STAFF RECOMMENDATION
404 North 17th Street
June 19, 2019

Application: New Construction—Outbuilding/Detached Accessory Dwelling Unit
District: Lockeland Springs-East End Neighborhood Conservation Zoning Overlay
Council District: 06
Base Zoning: R6
Map and Parcel Number: 08310004000
Applicant: Lynn Taylor, Taylor Made Plans
Project Lead: Melissa Baldock, melissa.baldock@nashville.gov

Description of Project: Application is to construct two outbuildings, a carport and a detached accessory dwelling unit (DADU), with footprints that together are approximately six hundred and fifty-two square feet (652 sq. ft.).

SITE PLAN

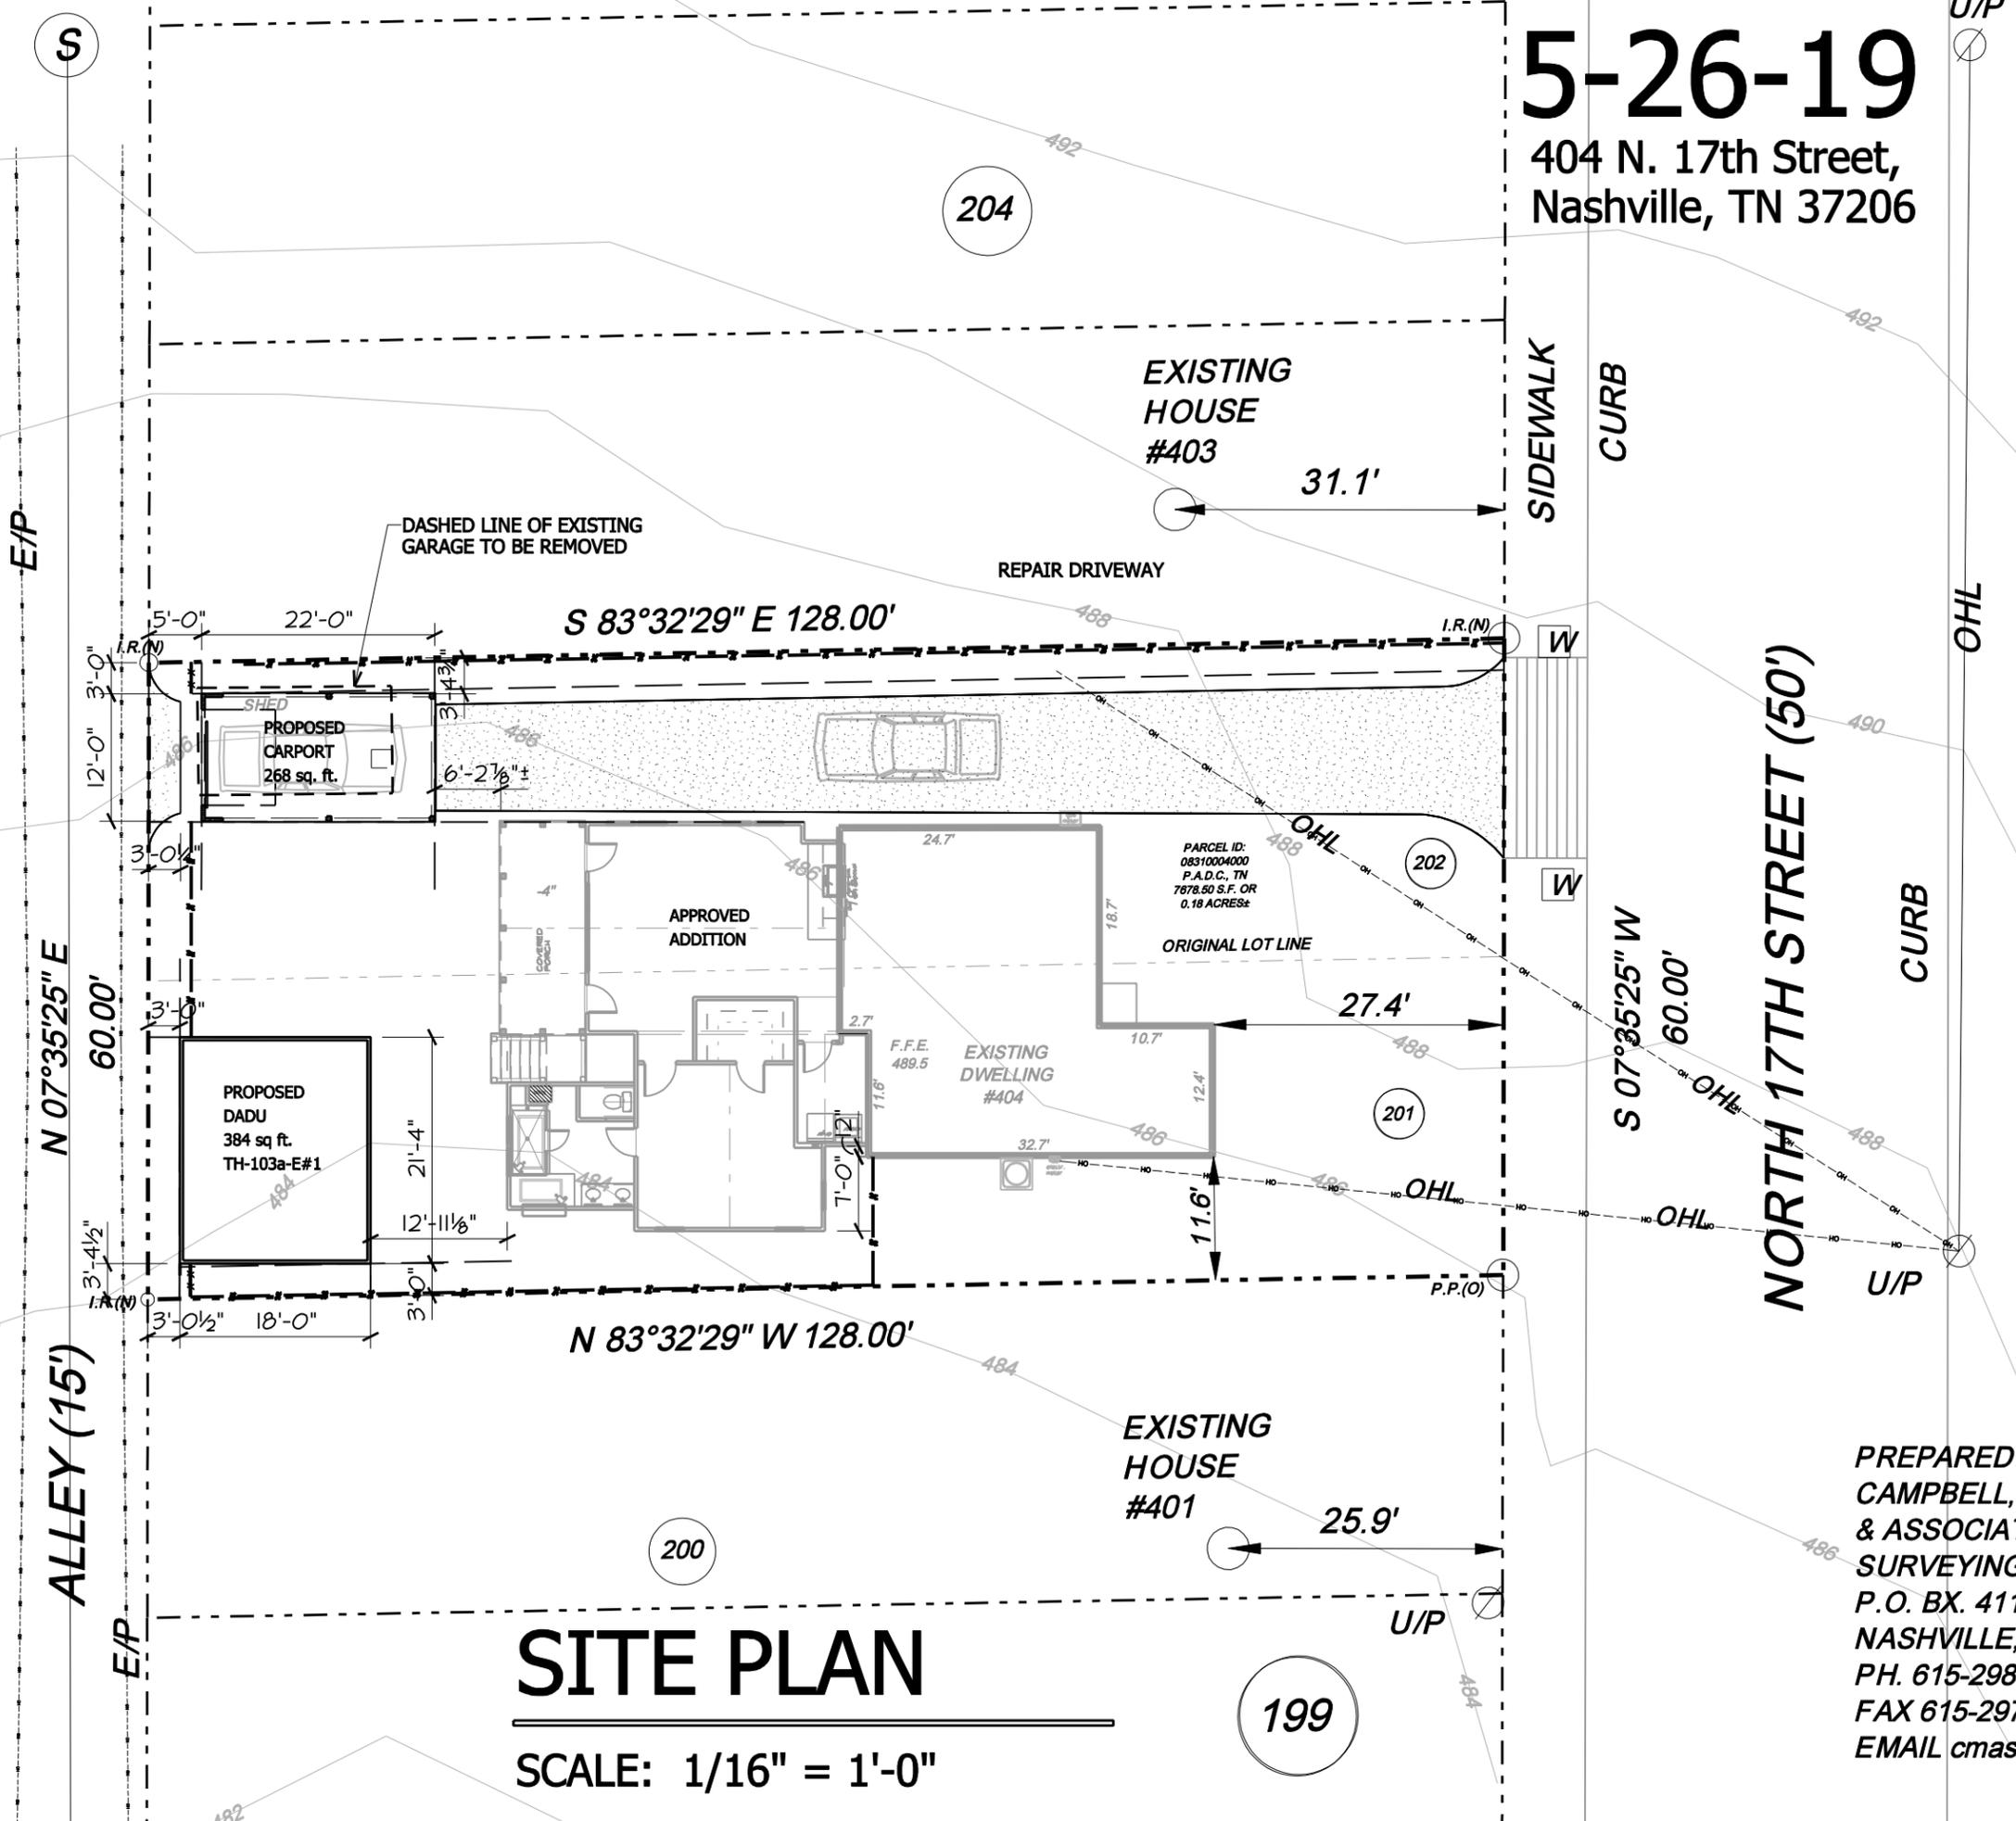
The proposed outbuildings have a combined footprint of six hundred and fifty-two square feet (652 sq. ft.). For outbuilding with a footprint of less than seven hundred square feet (700sqft), the setback requirements are as follows:

Minimum	Proposed Carport	Proposed DADU
Rear Setback	3' DADU; 5' Carport	5'	3'
Right Side Setback	3'	3'	35'
Left Side Setback	3'	47'	3'
Distance between principal building & outbuilding	10' for a lot of this depth	13'	6'3"

The design guidelines require twenty feet (20') of space between the back of a house/addition and any outbuilding. In cases where lots are unusually shallow, have constraining easements, or are unusually shaped, the Commission has frequently reduced the depth to ten feet (10'). Because this lot is unusually shallow at just one hundred and thirty feet (130'), staff finds that a reduced distance of ten feet (10') between the back of the house/addition and the DADU could be appropriate. Staff is supportive of the distance of six foot, three inches (6'3") between the carport and the back of the house because there is no overlap of the structures.
